Memorandum from the Office of the Inspector General

REQUEST FOR FINAL ACTION – EVALUATION 2017-15516 – HEAT RATE INPUT CALCULATIONS

HEAT RATE INPUT CALCULATIONS

Evaluation 2017-15516
June 30, 2018

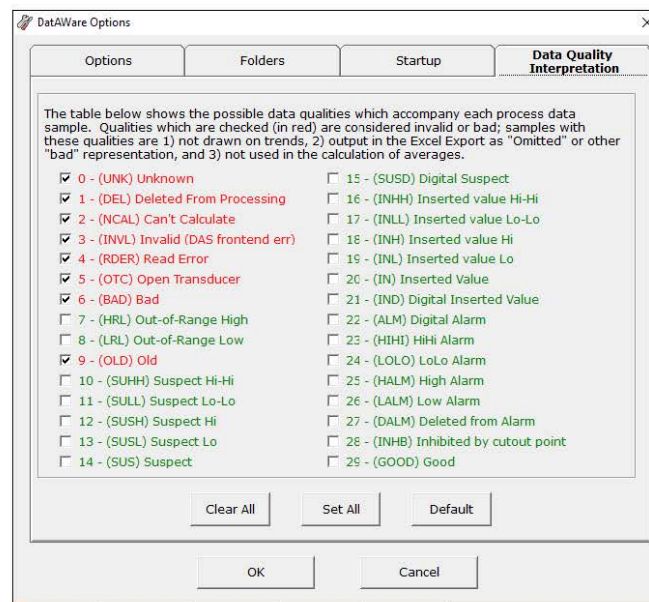
- Determine and document appropriate settings to be utilized in coal plant hourly reference heat rate calculations.

The coal plant calculations involve extracting unit data using a software called DatAWare, a data historian. The data collection settings in DatAWare will be documented in the procedure for data collection, *CO-SPP-09.050.01 – Operating Statistics & Station Economy Report Procedure*, by September 30, 2018. The settings are shown below:
